ADDENDUM #2: November 8, 2019

FROM: Allied Engineering, Inc.
160 Veranda Street
Portland, Maine 04103
Telephone: (207) 221-2260

RE: Addendum No. **Two (2)** to the Bidding Documents for:
NEW MECHANICS GARAGE LITCHFIELD MAINTENANCE FACILITY MILE
MARKER 92.7

SHEET NUMBER: C-101
 CONTRACT: 2019.12
 3 OF 41

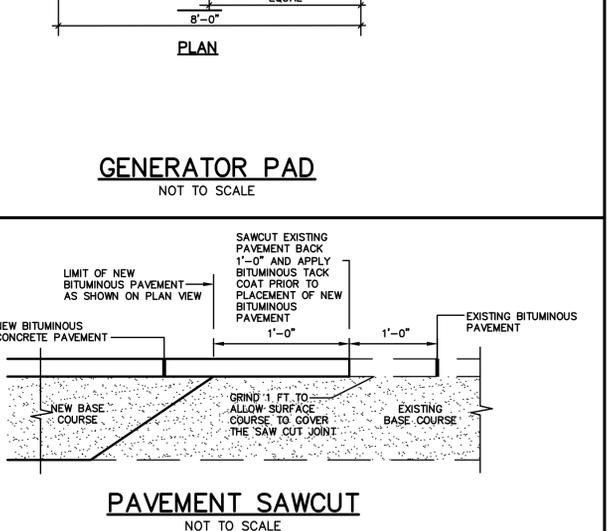
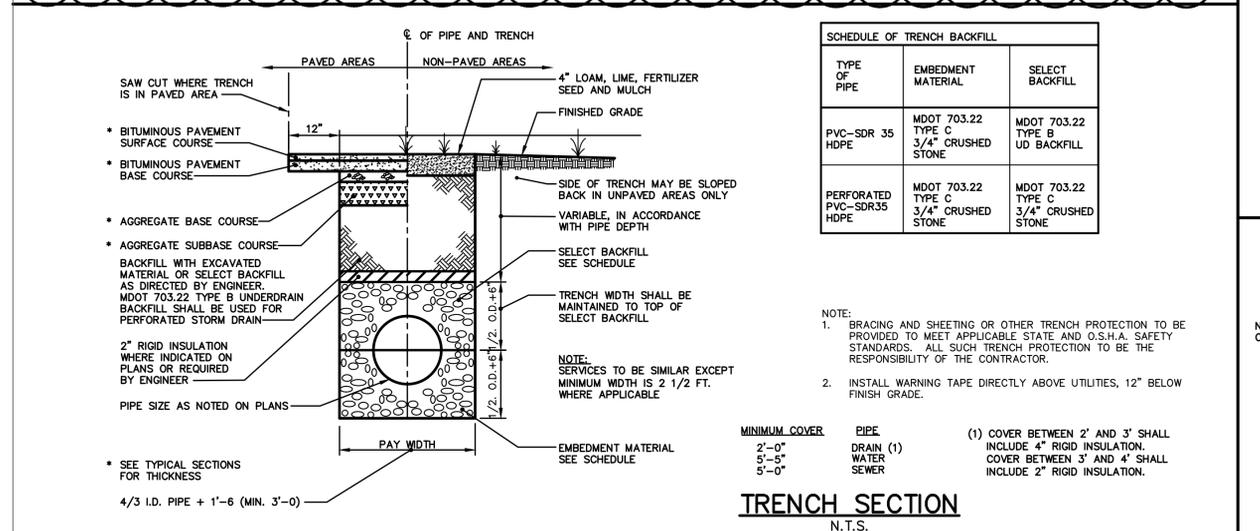
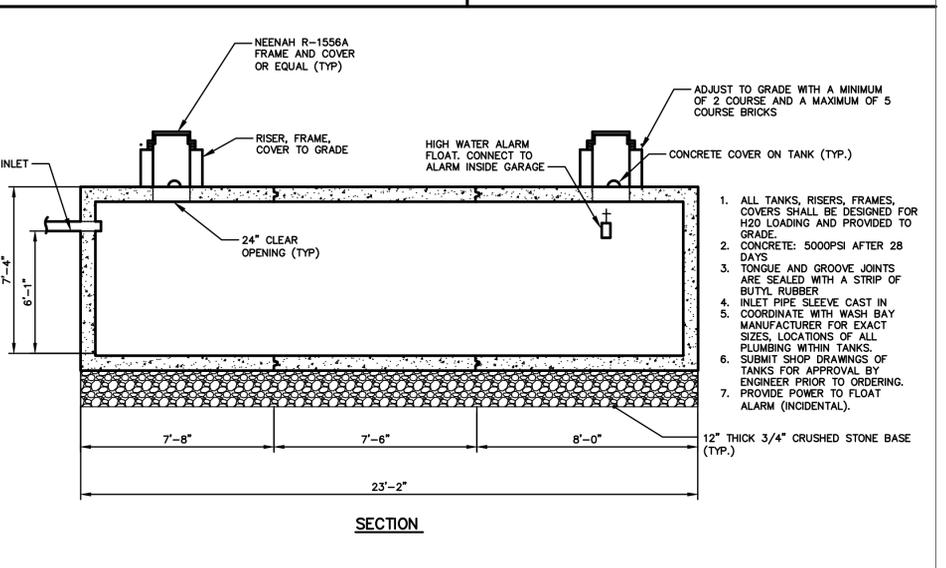
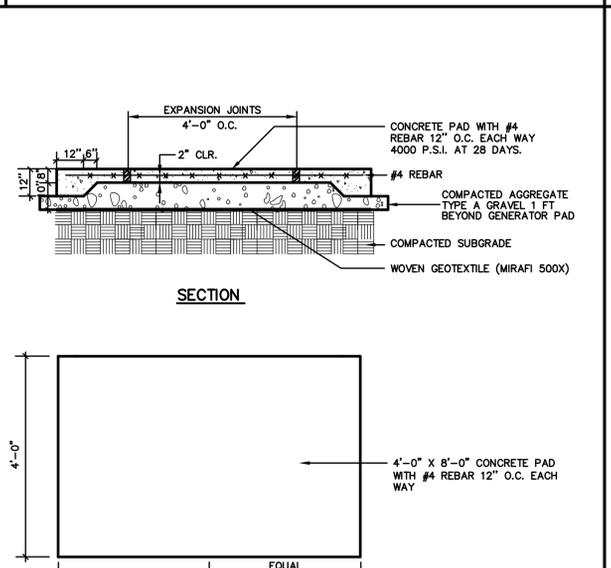
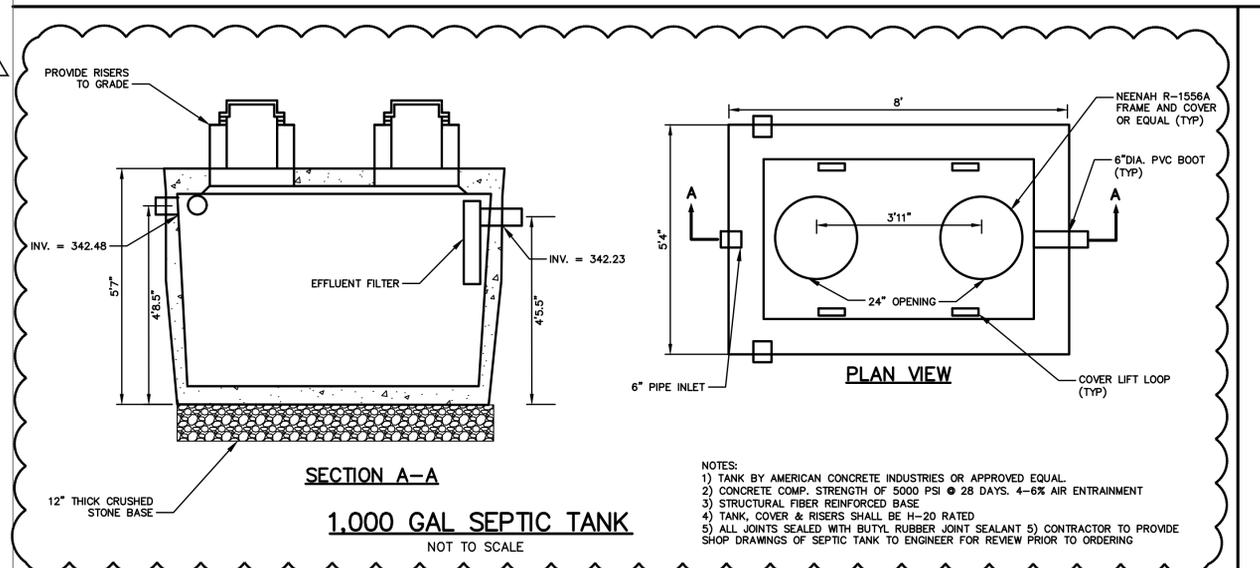
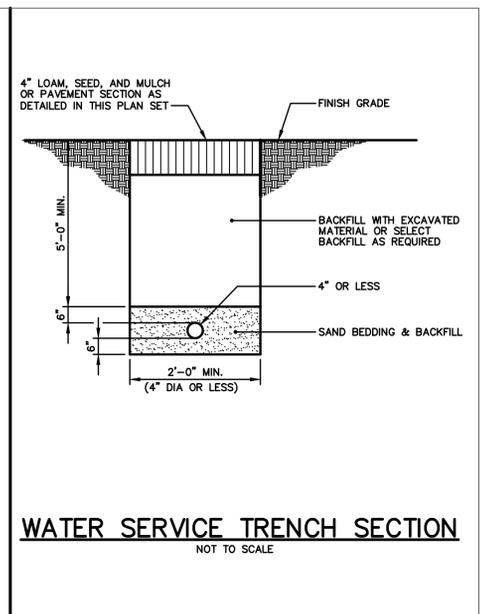
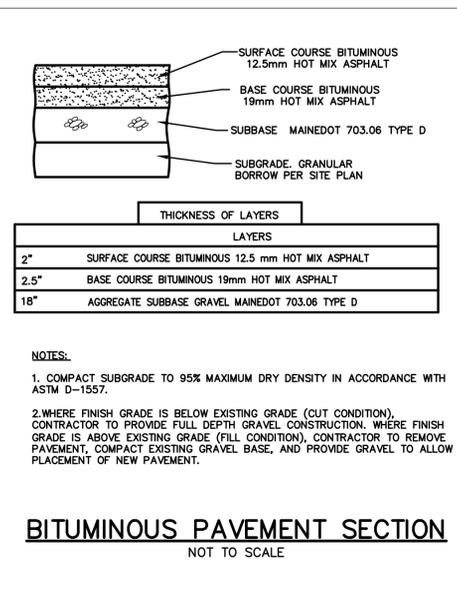
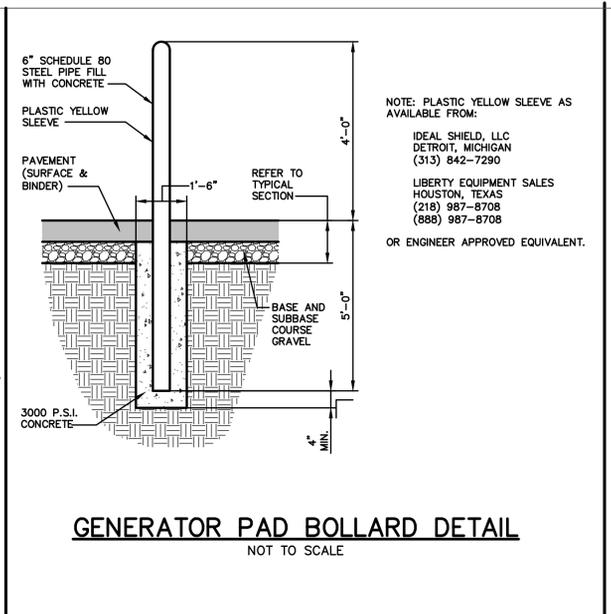
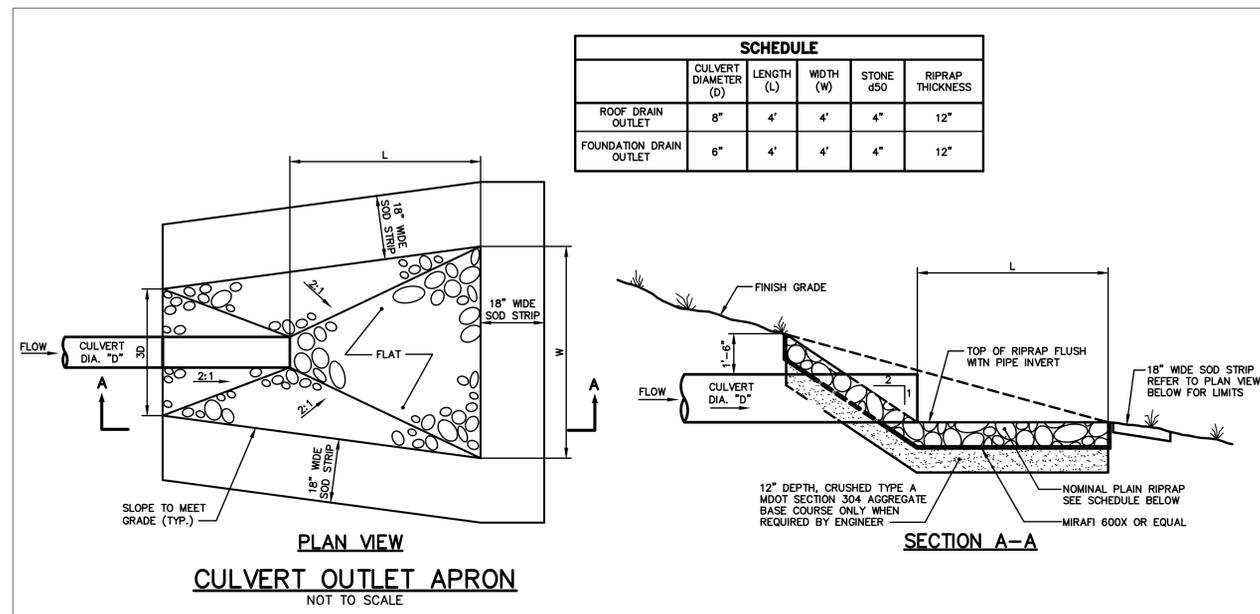
1. DRAWING C-101 SITE AND UTILITY PLAN: **DELETE** in its entirety and **ADD** in its place the revised sheets attached to this addendum. Drawing C-101 has been updated relocating the 6,000-gallon holding tank plan south of the initial location. The drawing also depicts a separate 1,000-gallon septic tank with a 4 ft diameter lift station. The force main to the septic system has been revised to 2" in diameter to match the specifications.

SHEET NUMBER: C-401
CONTRACT: 2019.12
5 OF 41

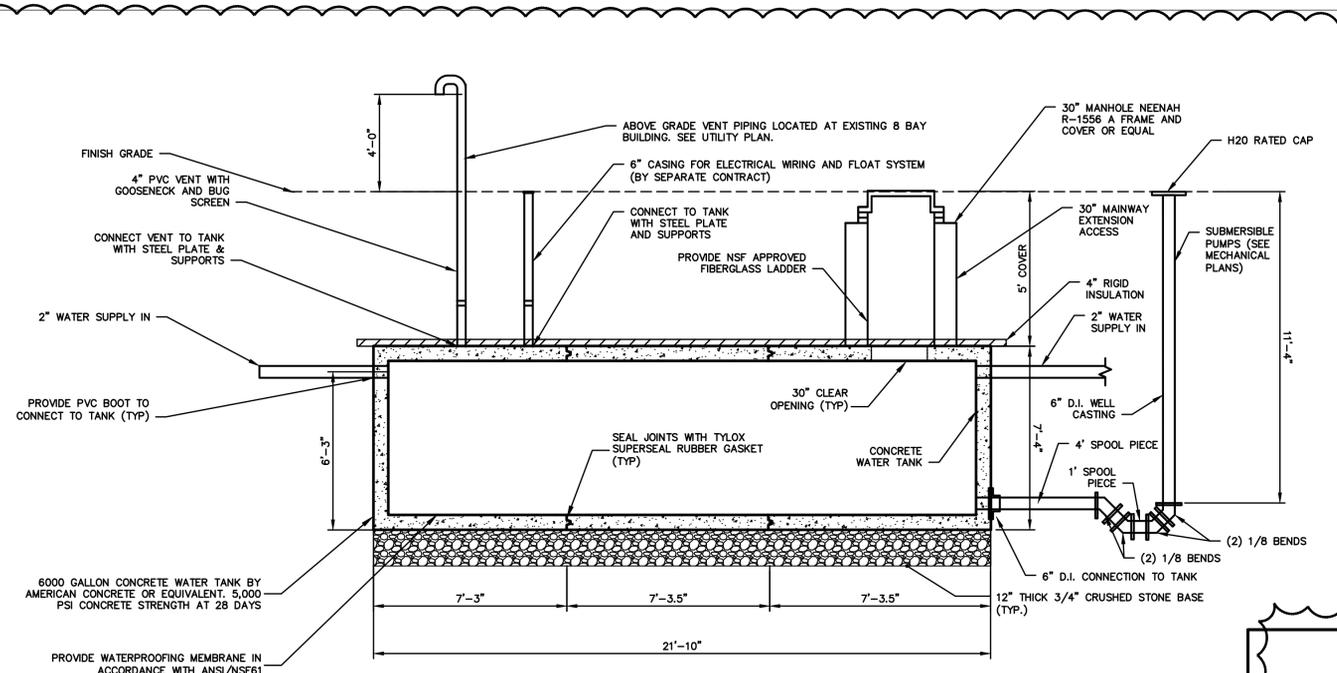
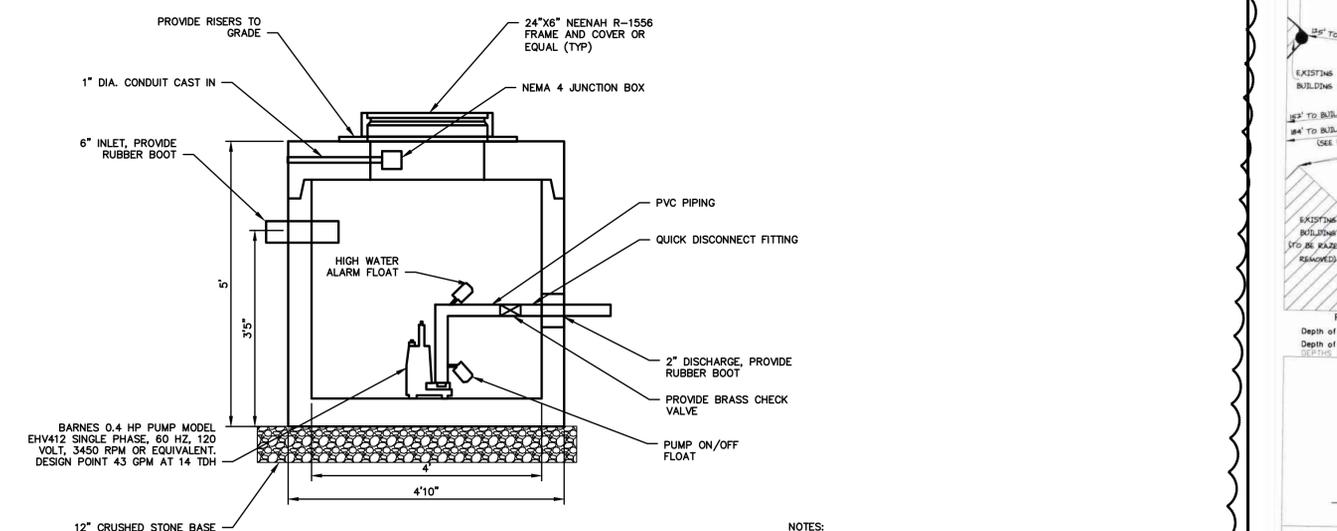
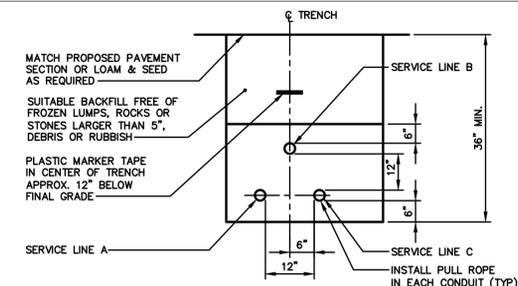
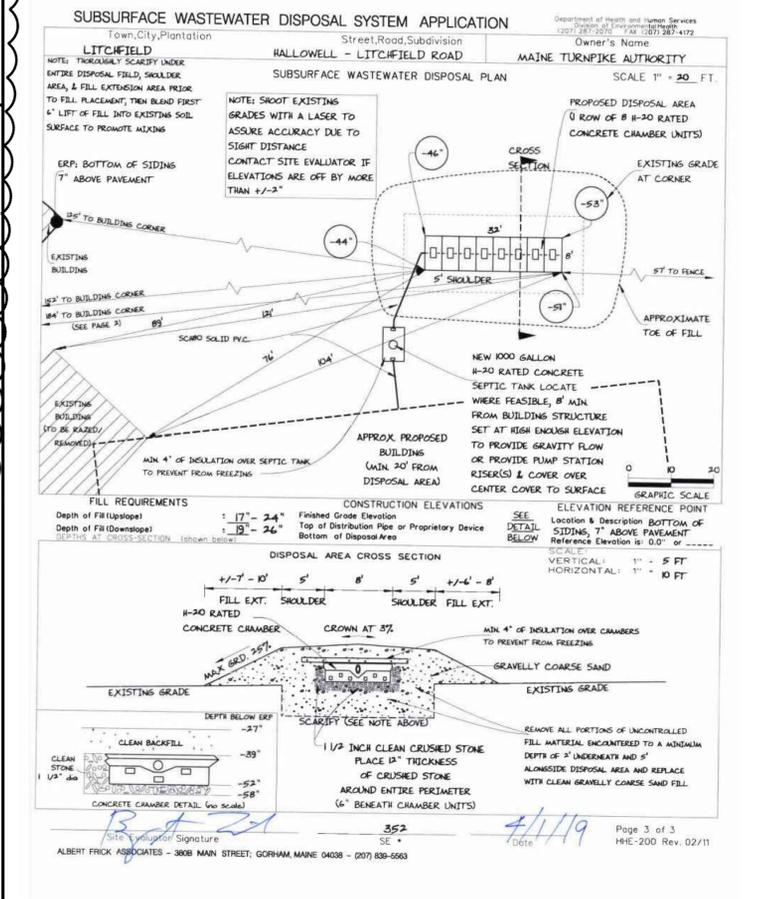
2. DRAWING C-401 DETAILS-1: **DELETE** in its entirety and **ADD** in its place the revised sheets attached to this addendum. Drawing C-401 has been updated removing the 1,000-gallon septic and lift station detail and replacing it with a 1,000-gallon septic tank detail

CONTRACT 2019.12, NEW MECHANICS GARAGE, LITCHFIELD MAINTENANCE YARD, MILE MARKER 92.7
DETAILS - 2
 SHEET NUMBER: C-402
 MTA PROJECT MANAGER: Brian A. Taddeo, P.E.
 CONTRACT: 2019.12
 6 OF 41

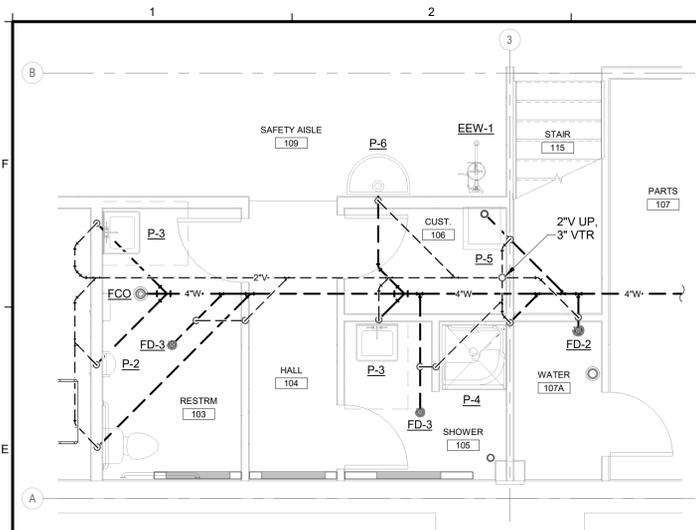
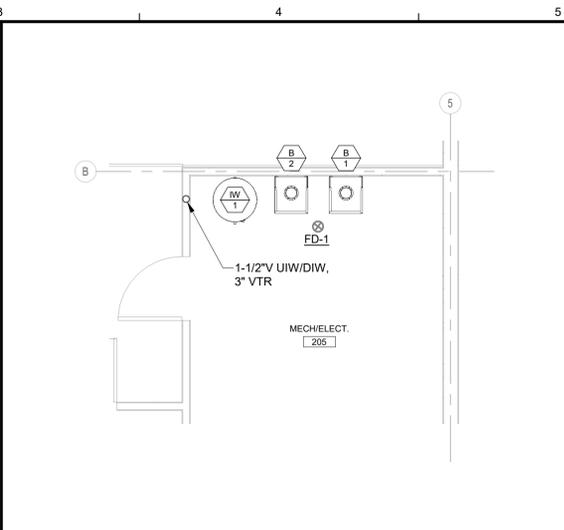
3. DRAWING C-402 DETAILS-2: **DELETE** in its entirety and **ADD** in its place the revised sheets attached to this addendum. Drawing C-402 has been updated removing the HDPE 5,000-gallon water tank and replacing with a 6,000-gallon concrete tank and well casing. A 4 ft lift station has been added that goes in line with the septic tank.

CONTRACT 2019.12, NEW MECHANICS GARAGE
LITCHFIELD MAINTENANCE YARD, MILE MARKER 92.7
SANITARY PIPING PLAN
SHEET NUMBER: PL-100
CONTRACT: 2019.12
29 OF 41

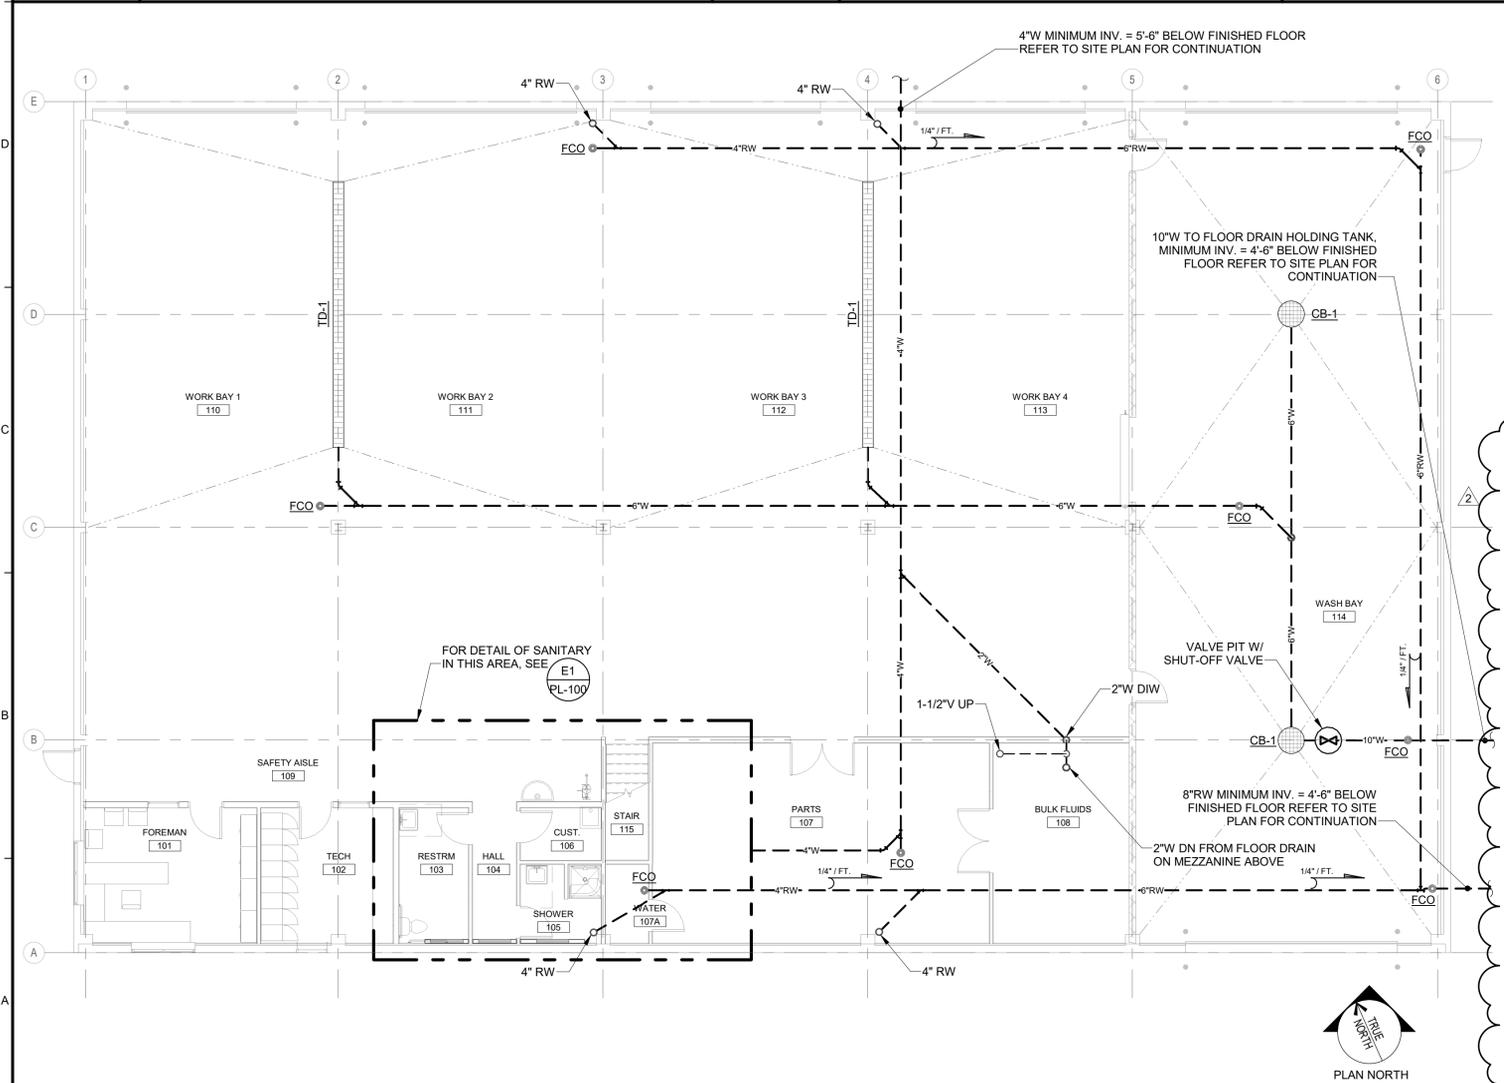
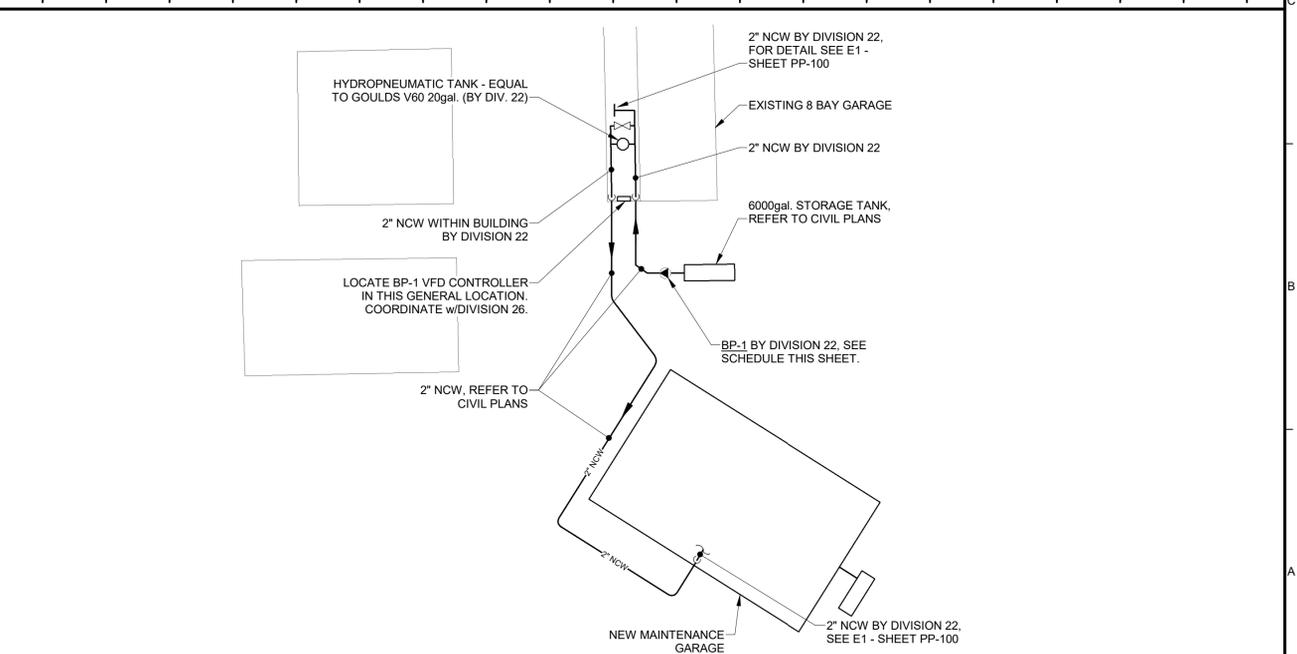
4. DRAWING PL-100 SANITARY PIPING PLAN: **DELETE** in its entirety and **ADD** in its place the revised sheet PL-00 attached to this addendum. Domestic Indoor Pump Schedule and Domestic Water Booster Pump Package have been revised and sheet Detail A6 has been revised.
